VALUE ENGINEERING PROPOSAL

PROPOSAL NO: S-8 PAGE NO: 1 OF 4

DESCRIPTION: Use Composite Piles for Chamber Foundation

DRAWING NO. 1

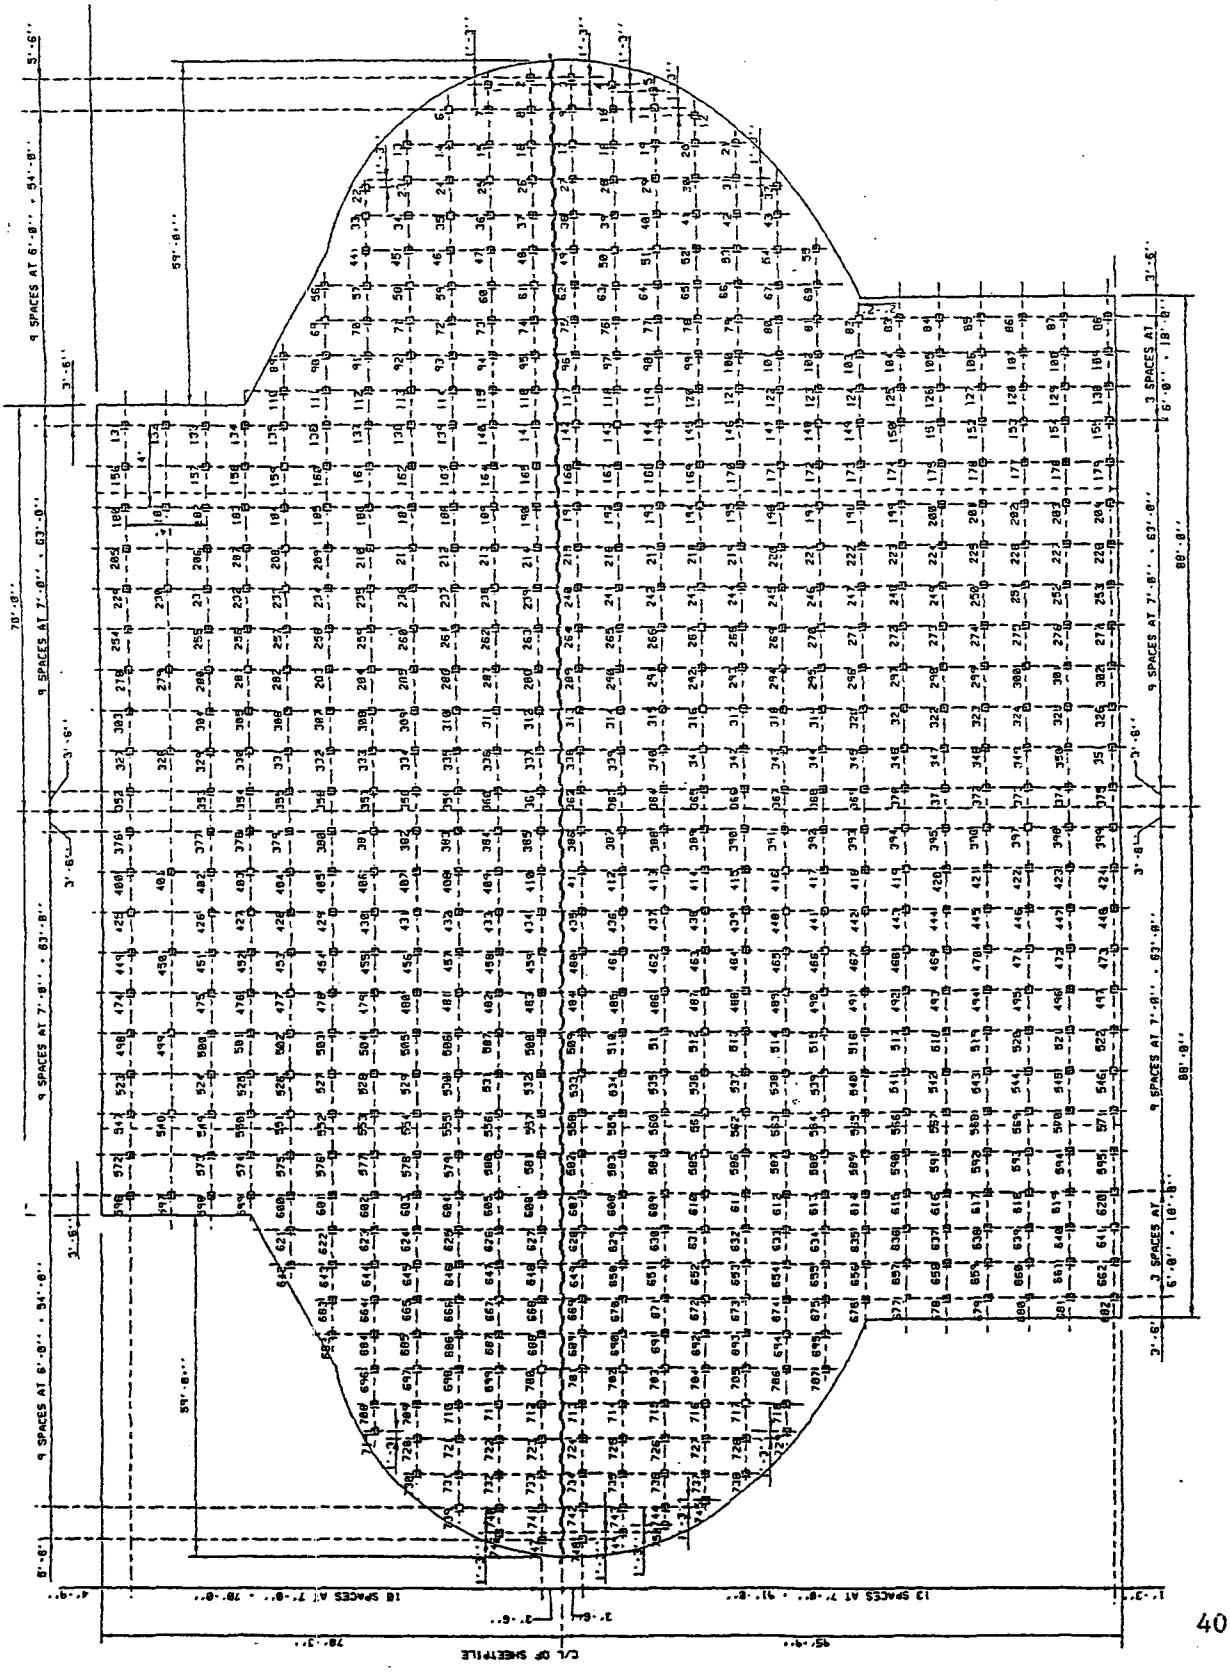
Specified 14" precast concrete piles, (750 per gate). (See Drawings Nos 1 and 2)

DRAWING NO. 2

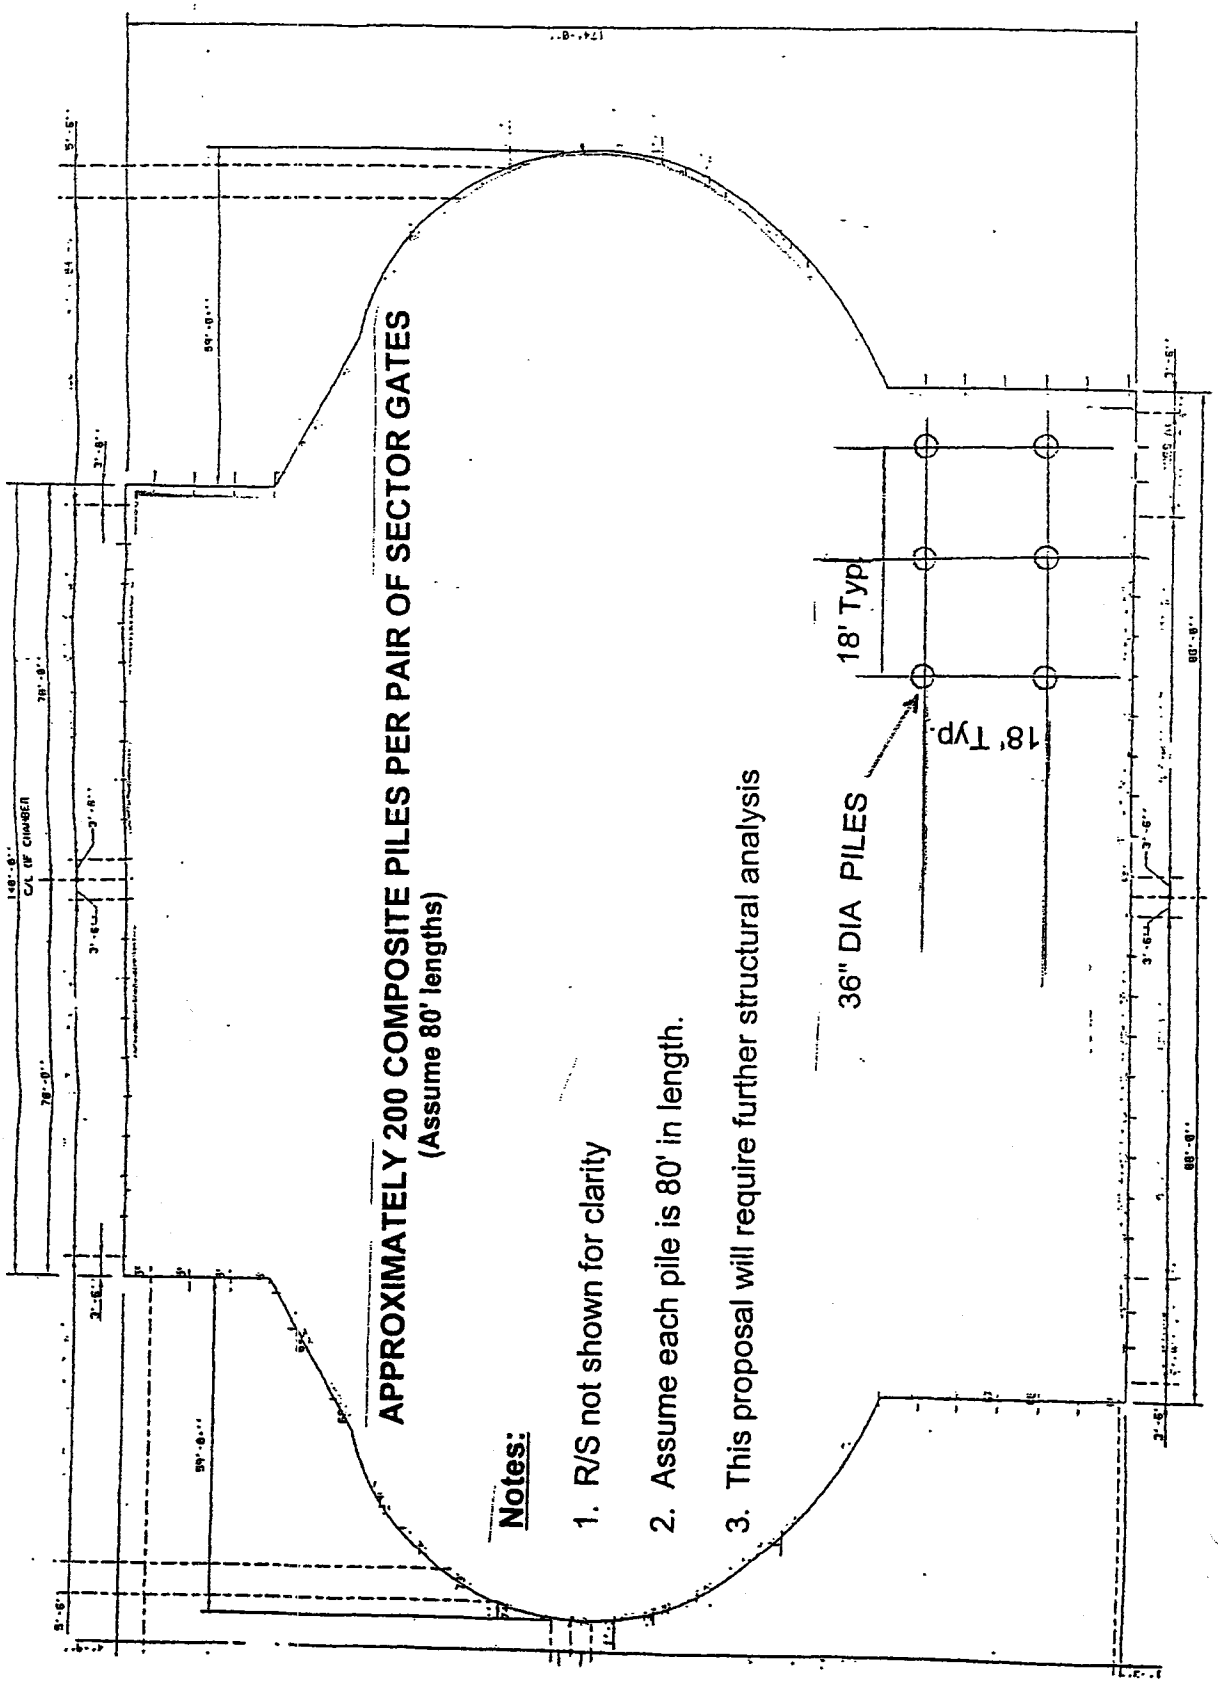
Specify composite piles for the foundation. (See Appendix E)

The overall justification for this proposal is the reduction in project costs and the reduction in construction requirements. Composite piles have greater skin friction values than concrete and their life cycle costs are better. Technically and economically the composite piles appear to be superior to concrete piles.
